Subject: Response to U.S. EPR Design Certification Application RAI No. 414, FSAR Ch. 7 OPEN

Request for Additional Information No. 414, Supplement 17

U. S. EPR Standard Design Certification
AREVA NP Inc.
Docket No. 52-020

Question 07.03-30:

Functional logic for actuation of containment isolation is shown in Figure 7.3-20—Containment Isolation.

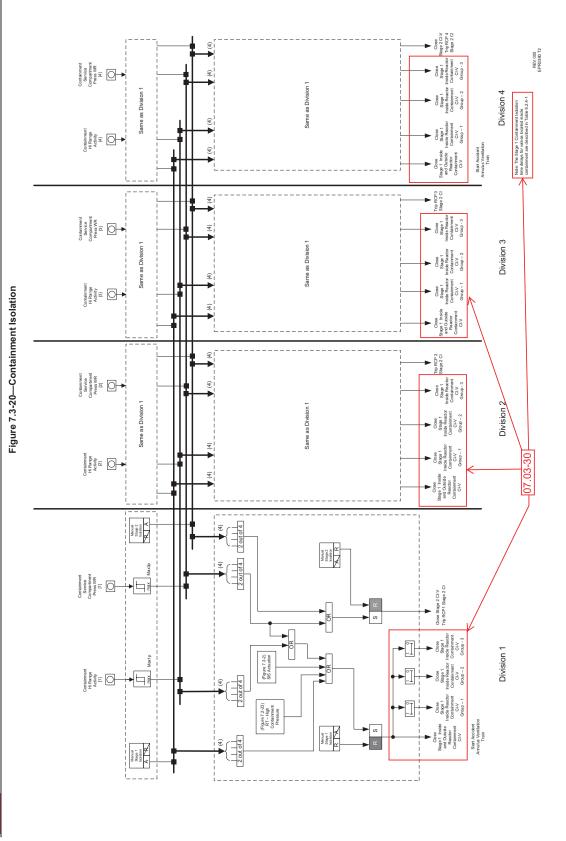
- 1. Explain and/or clarify exactly what components are involved in the 'response time testing' of the PS in the PS ITAAC and surveillance testing. The Chapter 15 definition remains somewhat vague and the presentation by the applicant on surveillance testing says that the testing is from sensor to final actuating device. The applicant's response to RAI Question 07.09.47 would seem to be in conflict with this.
- 2. Based upon the applicant's response to RAI Question 07.09.47, explain and/or clarify why the applicant believes that the PACS does not need to be involved in the overall response time testing of the PS. The PACS modules are specific to ESFAS and ESFAS actuations cannot occur without the PACS. They are digital devices that are part of the overall logic chain for an ESFAS actuation.

The applicant states that the PACS system has not been included in the response times. This appears to be in conflict with the definition of the response times for completion of ESF actuation in Chapter 15. The Chapter 15 definition makes no distinction between the compterized portions of the PS and the PACS, and implies that the response times would envelope all timing delays from sensor to final actuation device. Its should also be noted that the PACS ITAAC in U.S. EPR DCD, Tier 1, Section 2.4.5 makes no mention of response timing. Emergency Feedwater (EFW) is an ESF. The ITAAC for EFW is in U.S. EPR DCD, Tier 1, Section 2.2.4. There is no mention of response timing, in terms of valve stroke time with the PACS module, mentioned in the ITAAC. There is also no mention of response time testing in order to meet the bounding times of the Chapter 15 safety analyses. This appears to be in conflict with what the applicant states in its response to RAI Quesiton 07.09-47. If the response timing of the PACS is not listed in either the PS, PACS or any other ESF ITAAC, then the staff cannot have confidence that the as-built configuration of the PS will meet the bounding response times of the Chapter 15 safety analyses.

The closure sequence for inner CIVs in Divisions 1, 2, 3, and 4 is staggered to limit the "peak load" on the Class 1E uninterruptible power supply (EUPS) batteries and inverters. The staggered CIV sequence reduces the size of the EUPS batteries and inverters needed to achieve peak load. The time delay interval allows the motor operated valve (MOV) peak in-rush current to decay prior to energizing the next group of inner CIV MOVs. This staggering of the valves reduces the peak demand on both the batteries and the inverters.

The U.S. EPR EUPS system supplies the MOVs and therefore requires an output of 480V three phase. The MOVs normally create a large demand on the EUPS, and an even larger demand as a peak load because of the large starting current required to energize the MOV, which is typically five to seven times the running current. If numerous large MOVs are cycled simultaneously (such as for the non-staggered containment isolation signal), then the demand on both the battery and the inverter can be significant.

U.S. EPR FSAR Tier 2, Sections 6.2.4, Table 6.2.4-1, Section 7.3.1.2.9, and Figure 7.3-20 will be revised as described in the response and indicated on the enclosed markup.
